DUKE POWER COMPANY

OCONEE NUCLEAR STATION, UNIT 1

ATTACHMENT TO LICENSE AMENDMENTS NO. 2

CHANGE NO. 12 TO TECHNICAL SPECIFICATIONS FOR FACILITY LICENSE NO. DPR-38

FIGURE 6.1-1

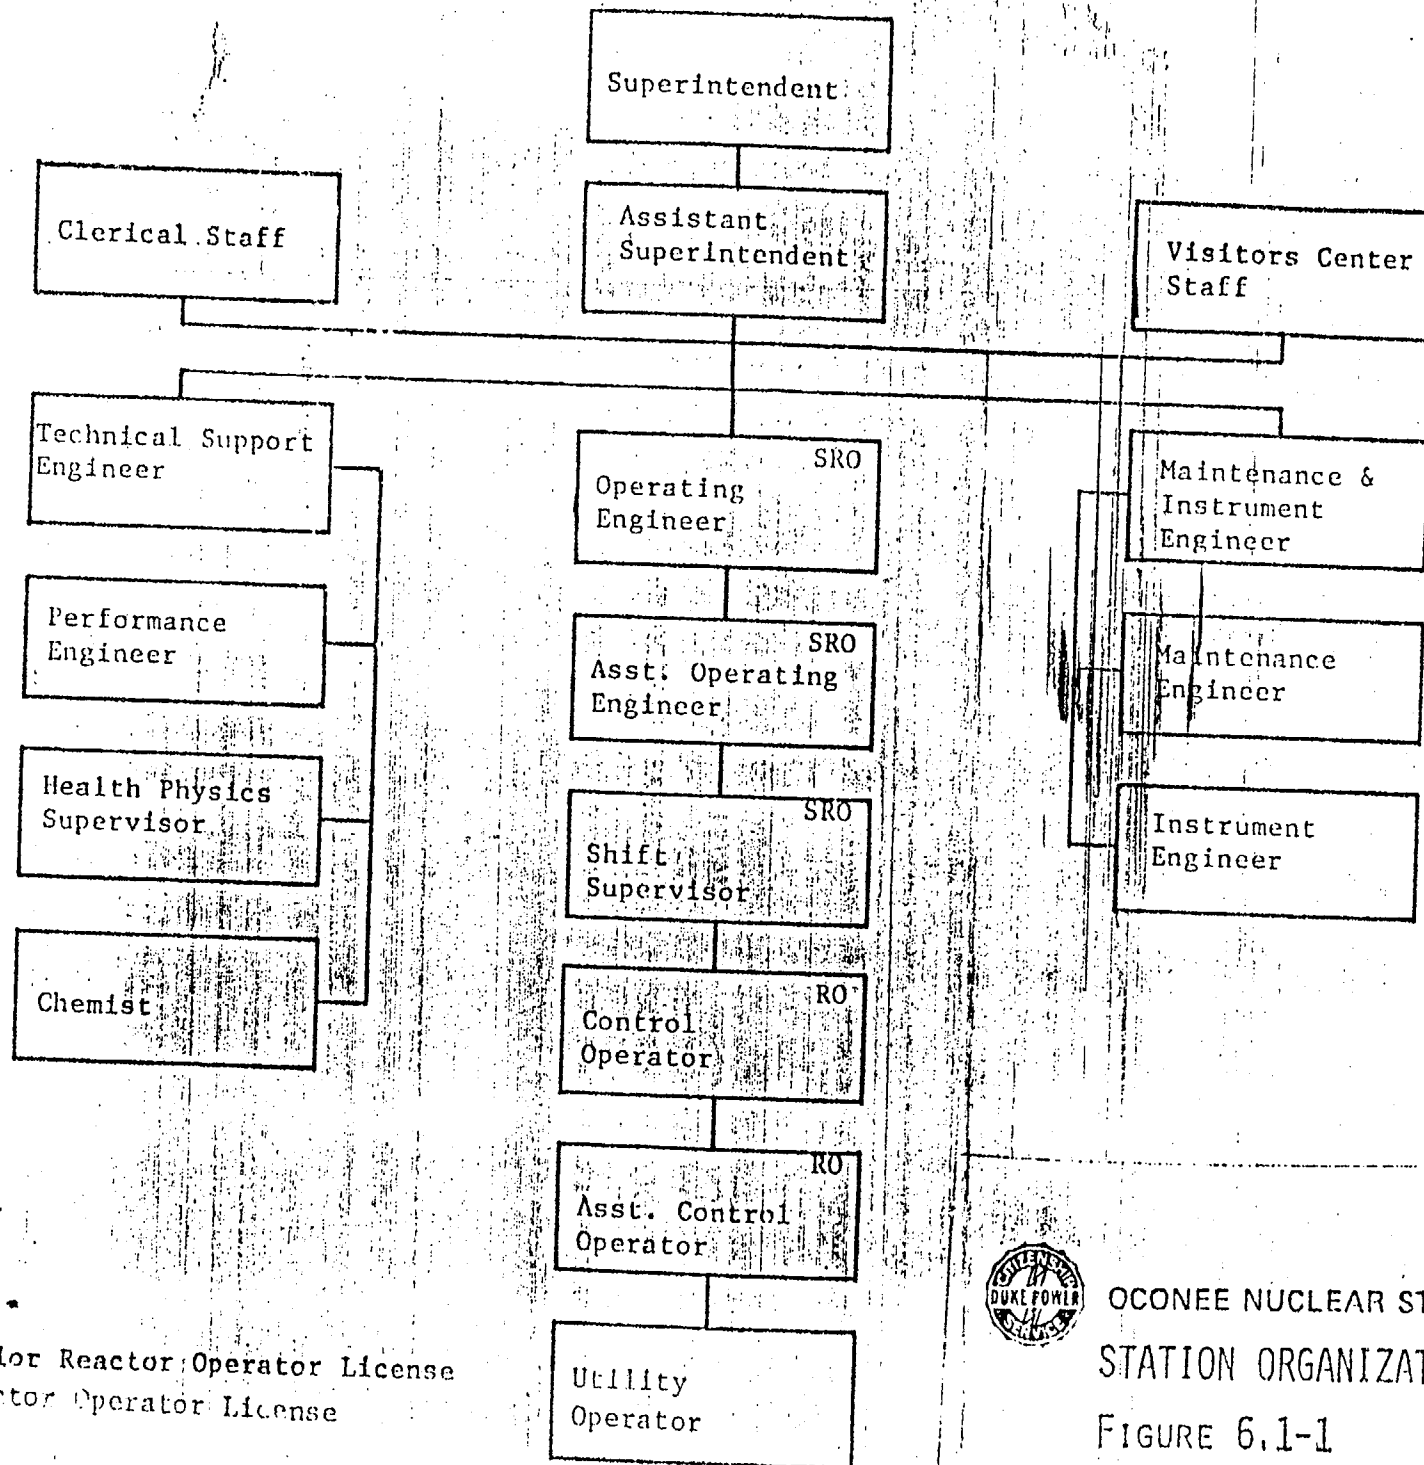
Replace Figure 6.1-1 with the attached.

The significant changes in the station organization in this proposal are as follows:

- (1) Instrument and control personnel will be moved from the Technical Support Group and will report to an Instrument Engineer who in turn will report to the Maintenance and Instrument Engineer.
- (2) Health physics personnel will report to a Health Physics Supervisor and chemistry personnel will report to the Station Chemist. Both supervisors will report to the Technical Support Engineer. At present, chemistry and health physics personnel report to the same supervisor.
